SUBJECT TO SECTION 4.55 CHANGE

Schedule of Amendments:

691 Pittwater Road

Ground Floor Plan

Sections 04

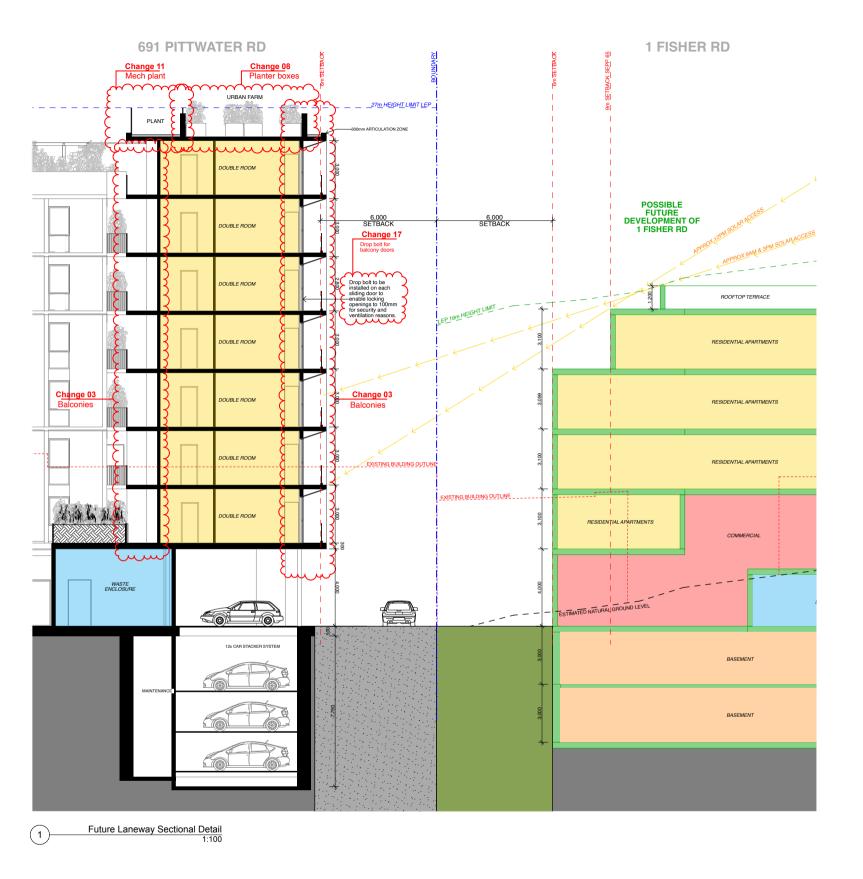
Rooms at the front and rear of the boarding house have been reconfigured to accommodate balconies, to increase amenity for lodgers. The balconies do not encroach into required setbacks, with only the balustrade within the 300mm articulation zone. Access to the balconies is proposed via a glazed sliding door, which also provides improved access to daylight and natural ventilation for these rooms. Frameless glass balustrades are proposed to allow the strong vertical proportions of the façade to be maintained. To offset the reduction in floor area of each room, the corridor walls have moved 500mm towards the internal void. Corridor widths for accessibility have been maintained, as has 1 m between the corridor balustrades and central core required for the corridor to be considered unenclosed. This reconfiguration does not affect compliance with FSR controls.

8 – Planter boxes:
To address concerns with waterproofing, the masonry planter boxes are proposed to be replaced with pots. The rearrangement of landscaped areas within the Urban Farm has allowed the loss of landscaping associated with inclusion of the shared laundries and reconfiguration of the Southwest Rooms to be offset, for no net loss of landscaping overall.

The Urban Farm on Roof level has been shifted towards the rear of the building to create a dedicated area for locating mechanical plant. To ensure acoustic and visual amenity for residents, the mechanical plant are is proposed to be surrounded by an acoustic barrier in a powdercoat finish. The barrier is proposed to be 1500mm high, which does not encroach the allowable height limit. The barrier will also act a balustrade, providing safe access for maintenance.

17 – Drop bolt:Drop bolt to all balcony doors for security/ventilation. Typical
